# WOODBRIDGE SCHOOL DISTRICT New Woodbridge High School Bid Pac A

ADDENDUM NO.3 23 July 2012

Woodbridge School District New Woodbridge High School

ARCHITECT'S PROJECT NO: 11109

## 4.18 <u>Drawing S32-04:</u>

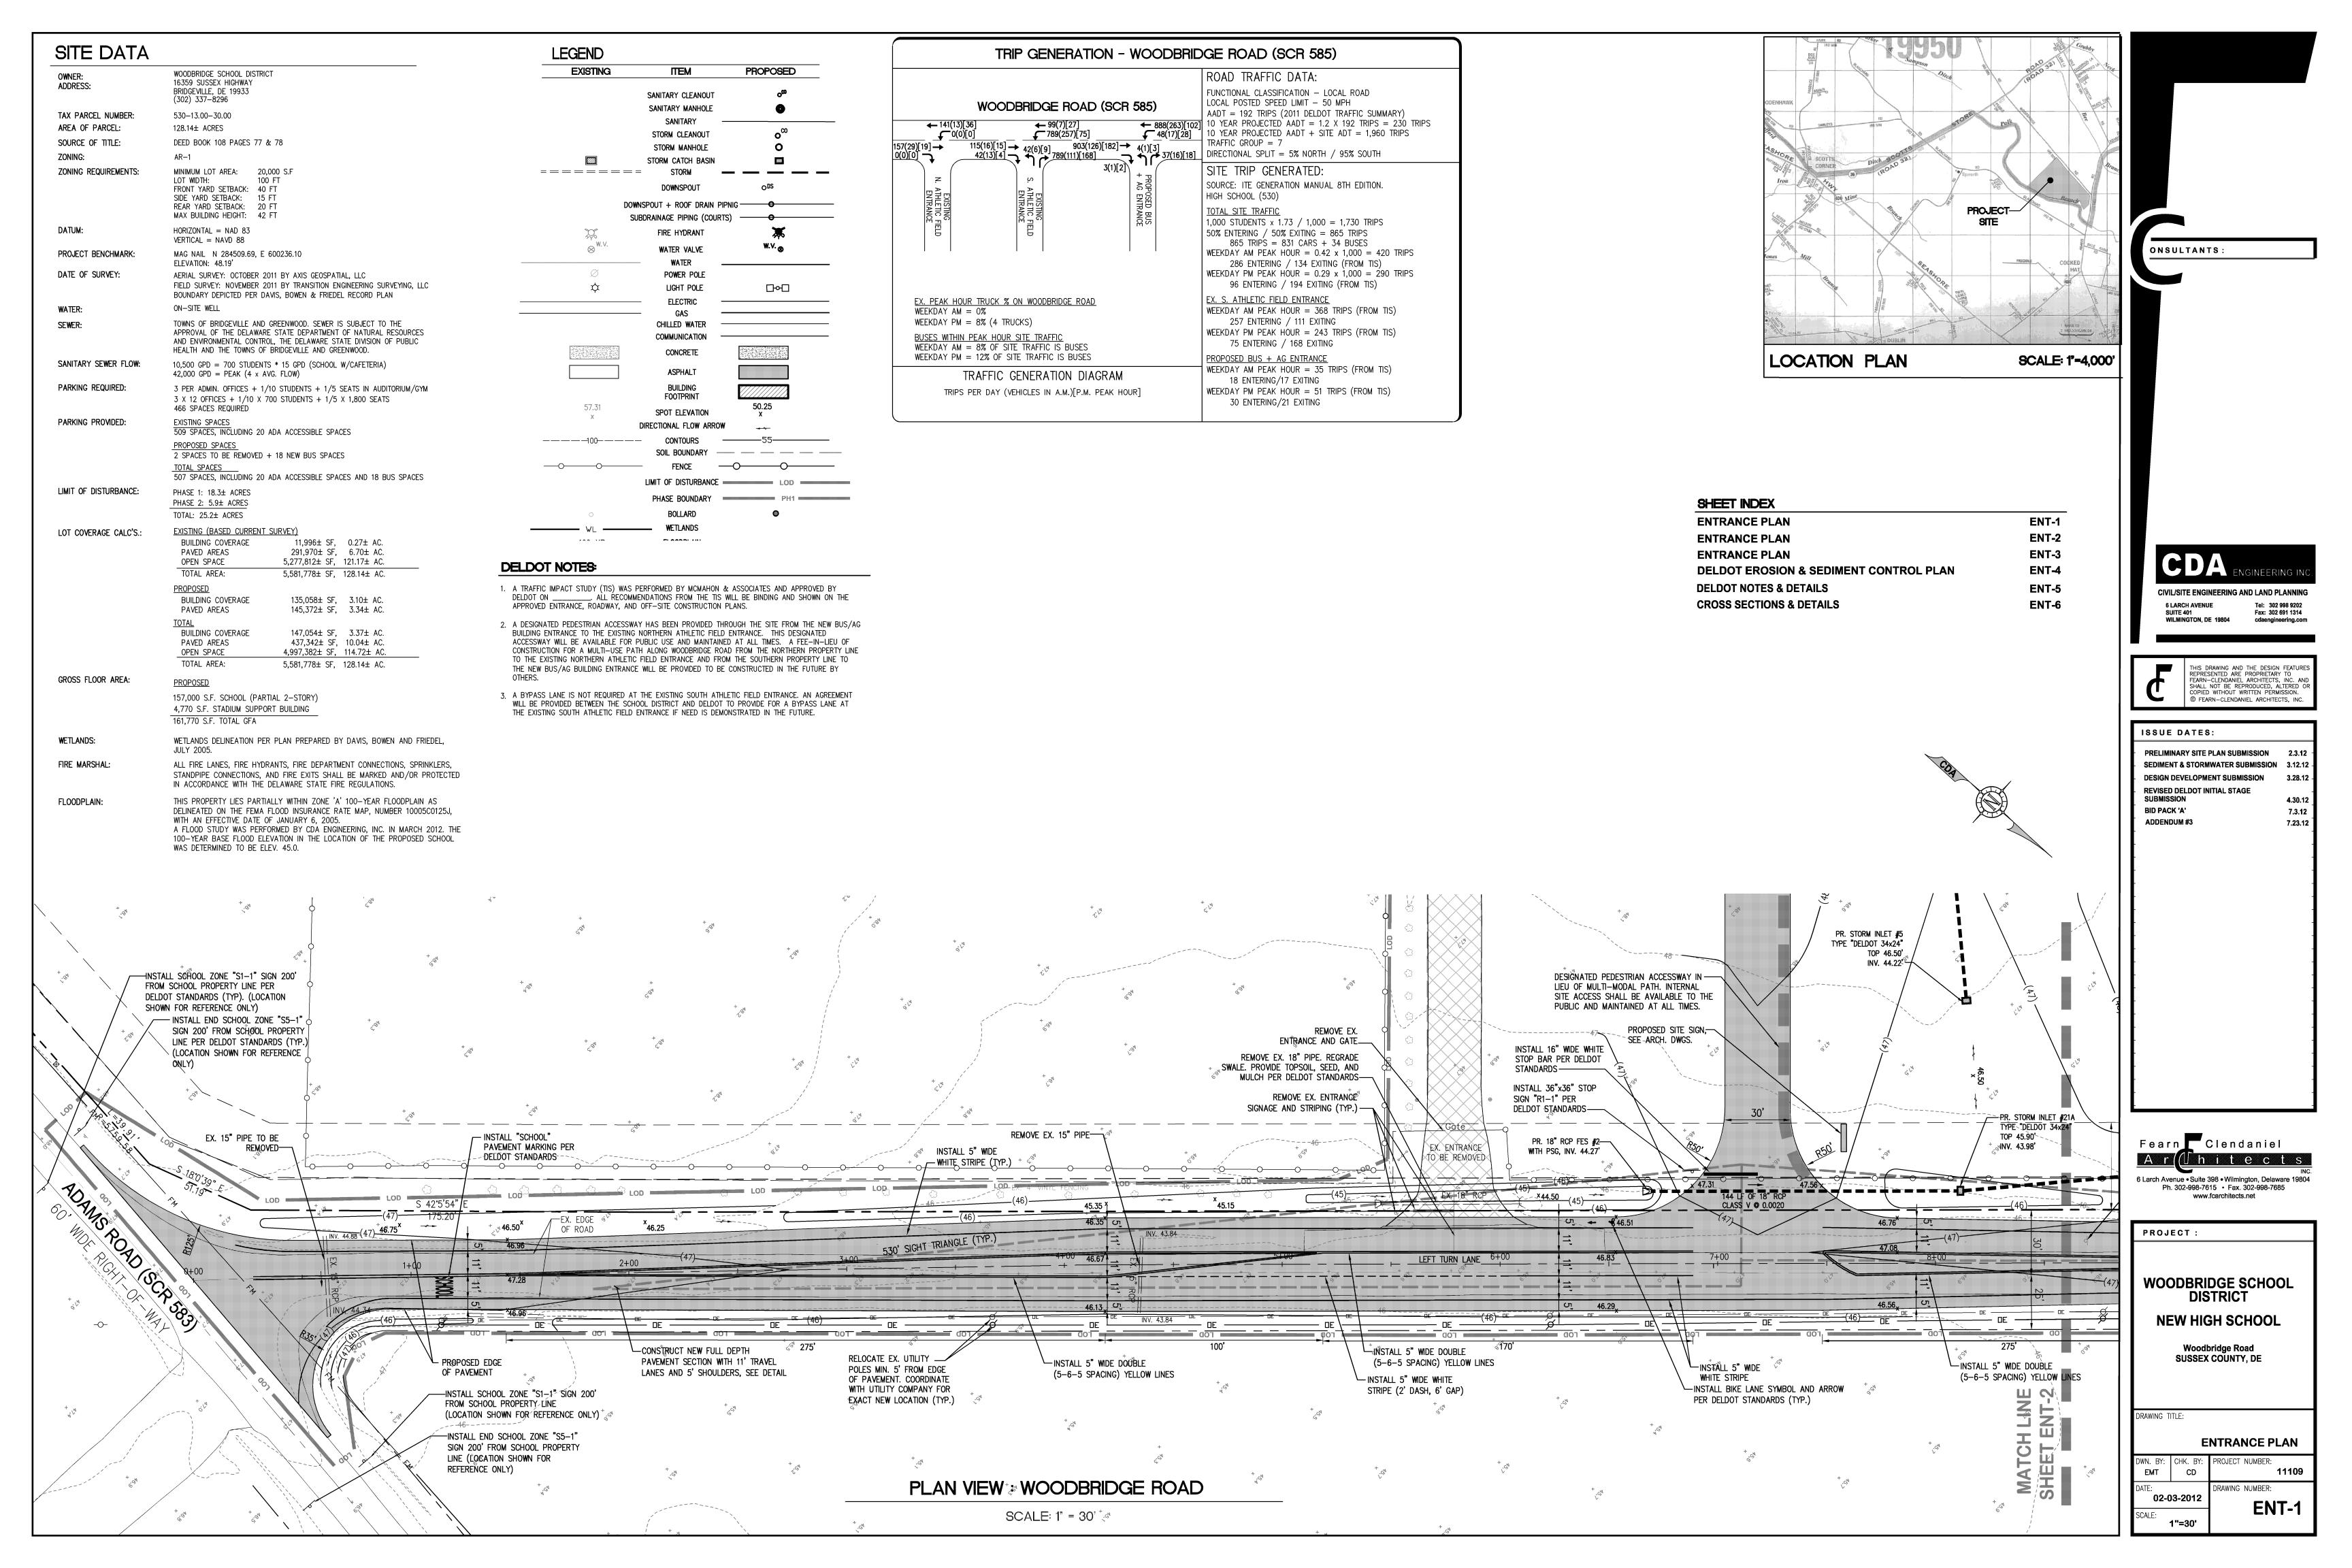
- a. <u>Section 3:</u> Bent plate to be continuous for full length of rake. Miter at corner and connect/coordinate with bent plate shown on 1/S32-04.
- b. <u>Section 6A:</u> Field weld or bolt curved angle to each outrigger. Move angle to bottom flange at two side walls (low side without parapet).
- c. At Mechanical Platform 2, provide structural steel angle or bent plate pour stop at full perimeter. Modify sections 15, 15A, 17, 17A and 17B accordingly.
- d. Section 18: W 14x22's with mitered ends are not sloping ("SLP").

## 4.19 Drawing S32-05:

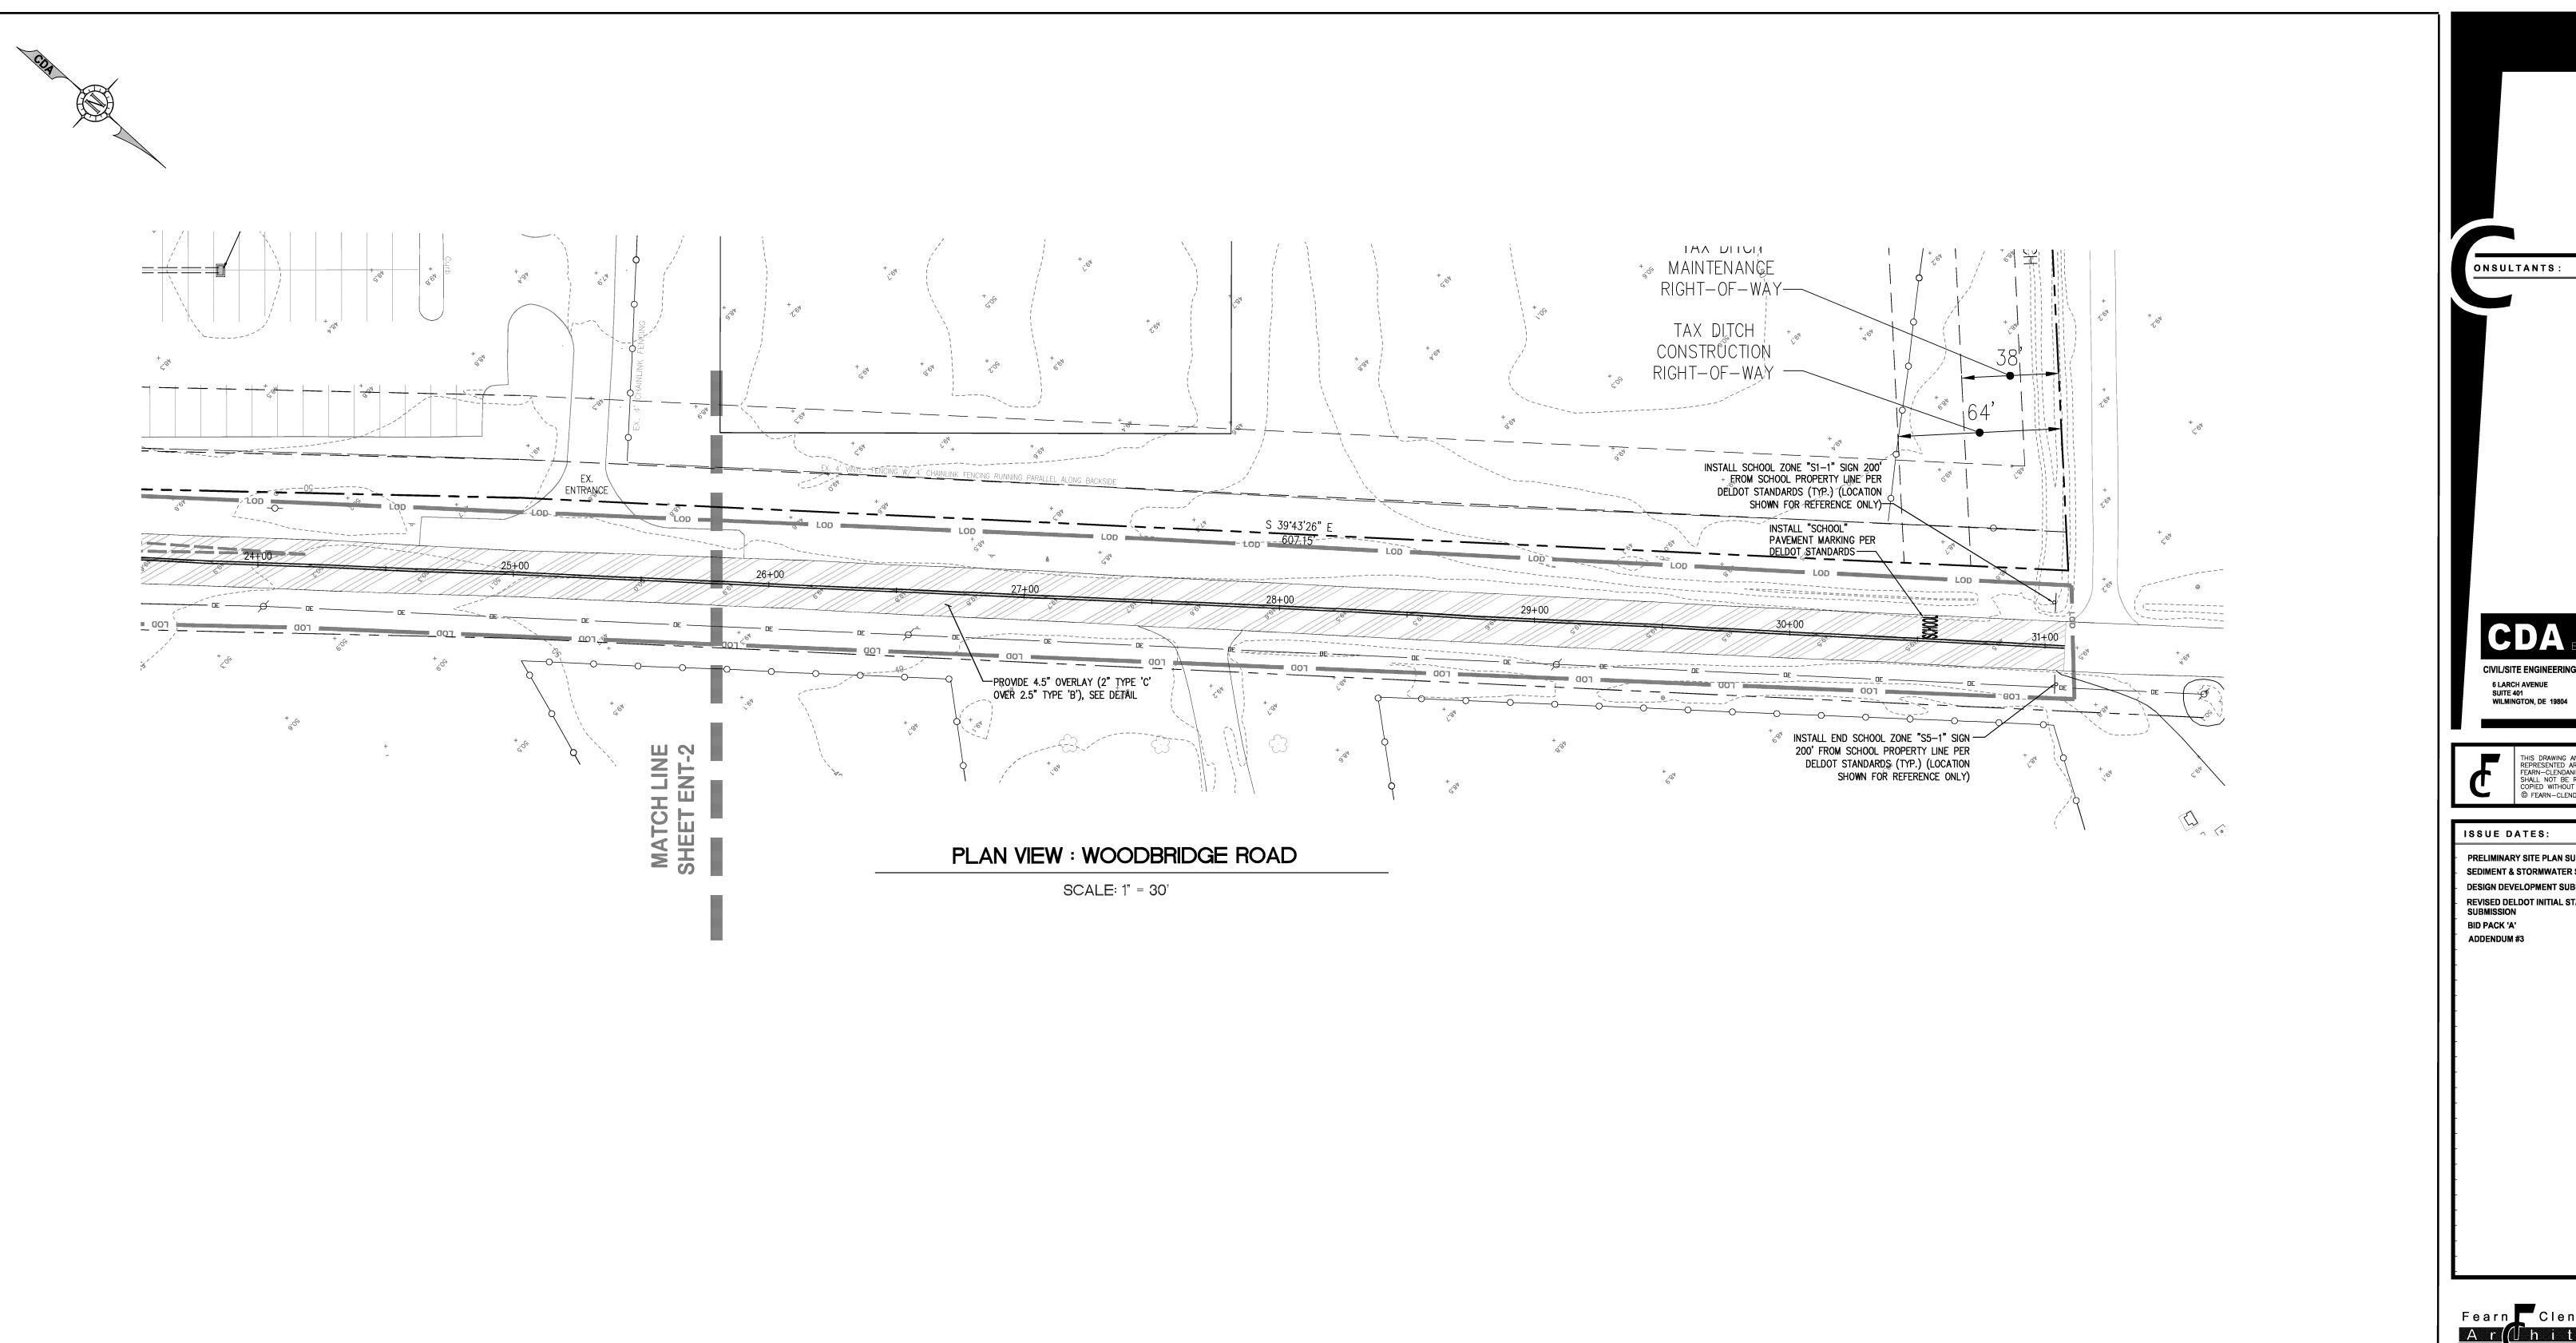
- a. <u>Section 2:</u> Horizontal truss is shown at incorrect elevation. Should be at bottom chord. Top of purlin should be located at bottom of deck.
- b. <u>Section 6:</u> Add continuous ¼" bent plate with stiffener at 24" o.c. similar to 3/S32-04 to support edge of deck.
- c. <u>Section 8:</u> Locate second purlin 5'-2 ½" from ridge at change in deck slope. Provide continuous ¼" bent plate on top flange to support deck from each side.

Provide continuous 12 gauge bent plate on top of deck. Provide W 12x14 beams at each sag rod.
